CITY OF ALBUQUERQUE

RE: **Lot 33 Block 8 Unit 5 SAD 227
7900 Marigold Dr. NW
Volcano Cliffs Subdivision
Grading and Drainage Plan
Engineers Stamp Date 7/13/2022 (E10D120)**

Based upon the information provided in your submittal received 7/14/2022, this plan is approved for Grading Permit and SO-19.

ENGINEER'S SEAL	LOT 33 BLK 8 UN 5 VC 7900 MARIGOLD DR	DRAWN BY DEM
		DATE 7-12-22
	GRADING AND DRAINAGE PLAN	C:Dem/RGS:DAVD SOULE:GSD:big
		SHEET # C1
7/13/22	DAVID SOULE P.E. #14522	JOB #

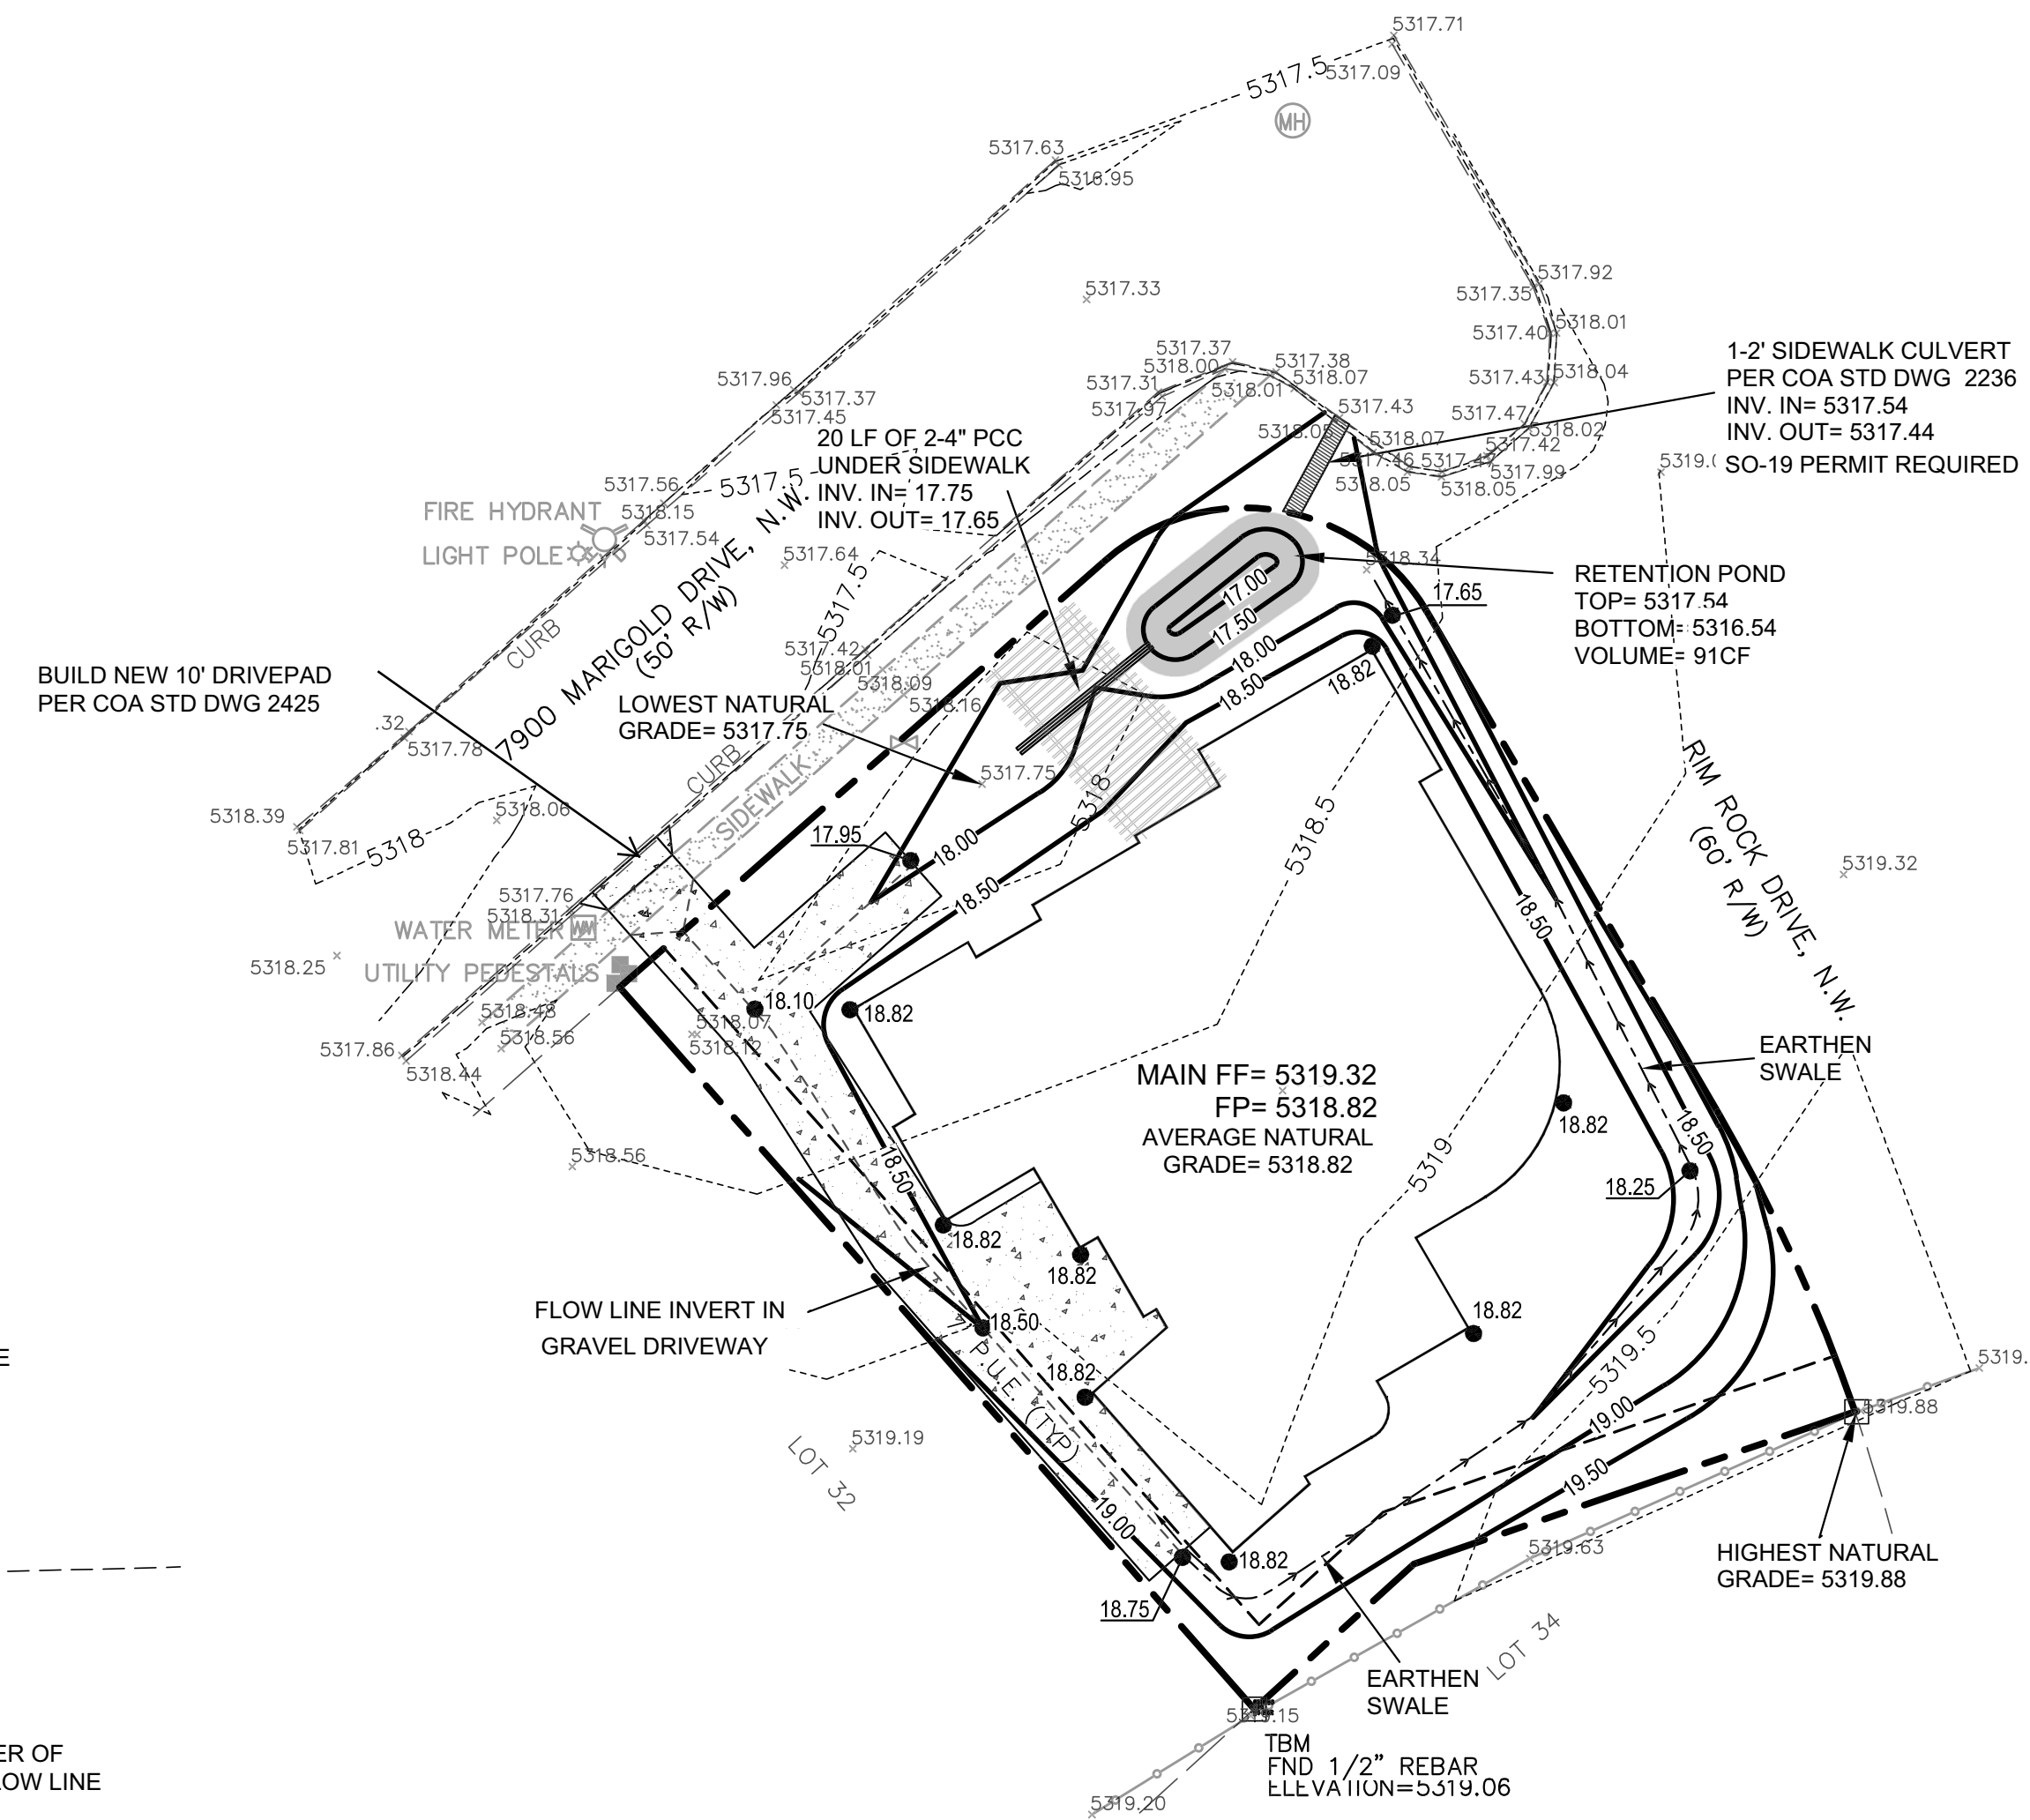
Prior to Building permit approval a Pad Certification will be required, provided by the Engineer or a registered Land Surveyor.

Advise the owner contractor not to use dirt as a ramp to climb the curb, use lumber or crusher fines for this purpose. Place this note on the plan.

Reiterate to the Owner/Contractor that a separate permit for a garden/retaining wall must be obtained with the approved G&D plan and Pad Certification. Also, if a swimming pool is to be placed after this approval a new grading and drainage plan will need to be resubmitted showing the changes for the land treatments.

Prior to Certificate of Occupancy release, Engineer Certification per the DPM checklist is required.
